LR-N02-0039  
LCR H02-04

**REQUEST FOR CHANGE TO TECHNICAL SPECIFICATIONS  
EXTENDED USE OF PRESSURE – TEMPERATURE LIMIT CURVES  
HOPE CREEK GENERATING STATION  
FACILITY OPERATING LICENSE NPF-57  
DOCKET NO. 50-354**

**HOPE CREEK GENERATING STATION  
FACILITY OPERATING LICENSE NPF-57  
DOCKET NO. 50-354**

**EVALUATION OF REVISIONS TO THE TECHNICAL SPECIFICATIONS  
FOR EXTENDED USE OF PRESSURE-TEMPERATURE LIMIT CURVES**

**Figure 3.4.6.1-1  
Hydrostatic Pressure and Leak Tests Pressure/Temperature Limits - Curve A**

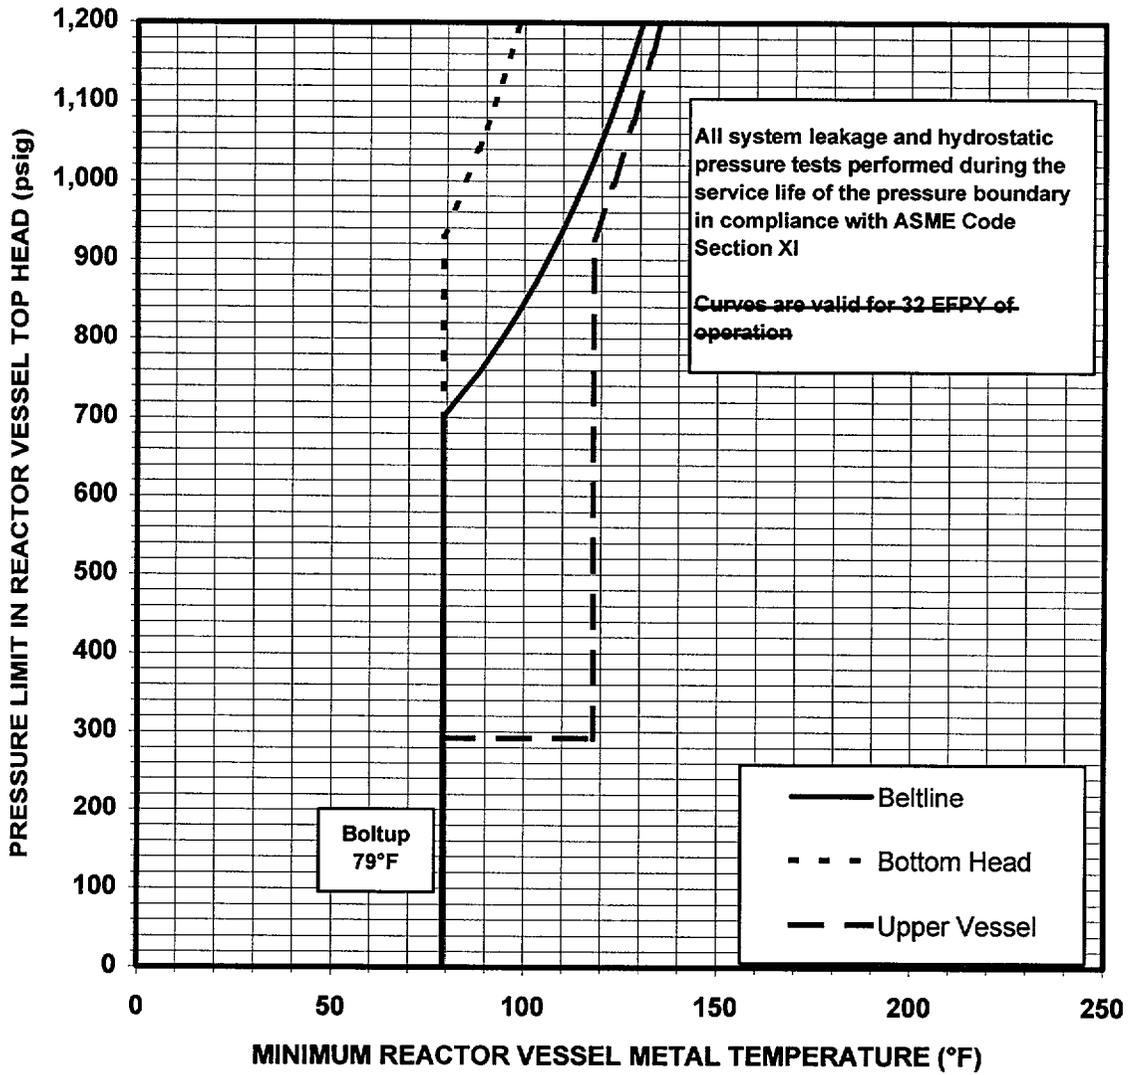
The proposed changes to the Technical Specifications would revise the footnote on Figure 3.4.6.1-1, "Hydrostatic Pressure and Leak Tests Pressure/Temperature Limits- Curve A," Figure 3.4.6.1-2, "Non-Nuclear and Cooldown Pressure/Temperature Limits – Curve B," and Figure 3.4.6.1-3, "Core Critical Heatup and Cooldown Pressure/Temperature Limits – Curve C." The current footnote states, "This figure is valid through Cycle 11 Operation in accordance with NRC Safety Evaluation supporting Amendment No. 131." The revised footnote will read, "This figure is valid through Cycle 12 Operation in accordance with NRC Safety Evaluation supporting Amendment No. \_\_\_\_."

For consistency purposes, the note on figures 3.4.6.1-1, 3.4.6.1-2 and 3.4.6.1-3 which states that the, "Curves are valid for 32 EFPY of operation" is being deleted.

Note: This figure is valid through Cycle 44-12 Operation in accordance with NRC Safety Evaluation Report supporting Amendment No. \_\_\_\_\_

Figure 3.4.6.1-2

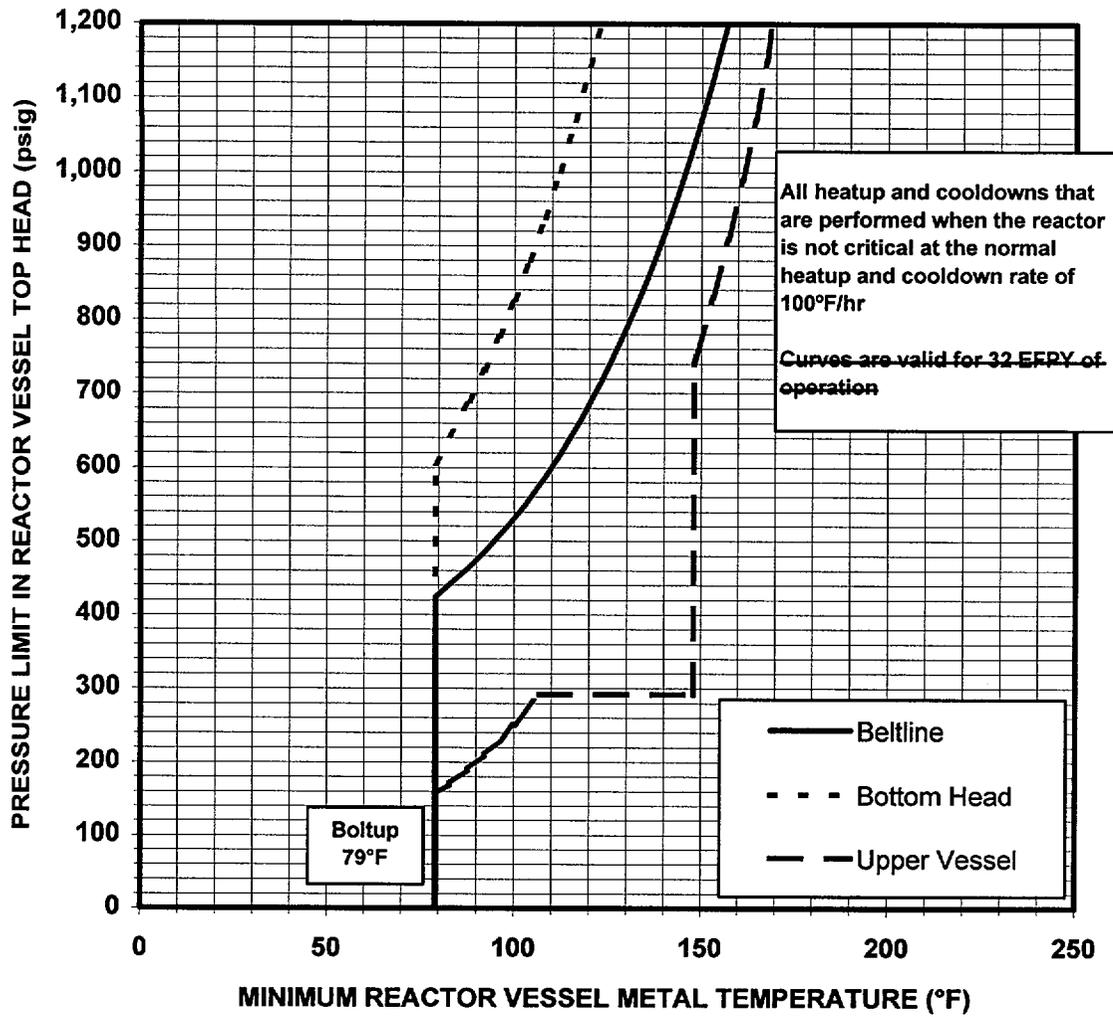
Note: This figure is valid through Cycle 44 12 Operation with NRC Safety Evaluation Report supporting Amendment No. \_\_\_\_\_

Figure 3.4.6.1-3

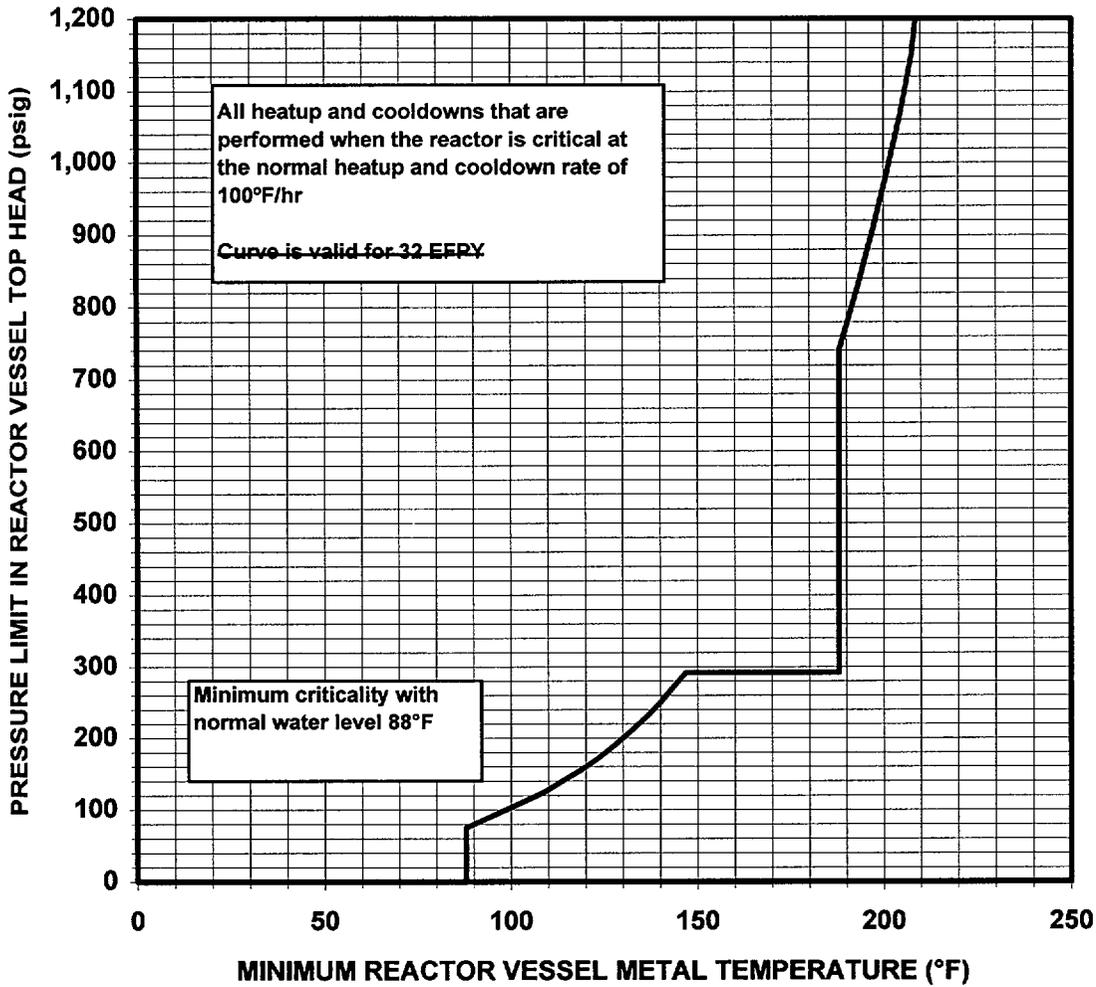
Note: This figure is valid through Cycle 44 12 Operation in accordance with NRC Safety Evaluation Report supporting Amendment No. \_\_\_\_\_
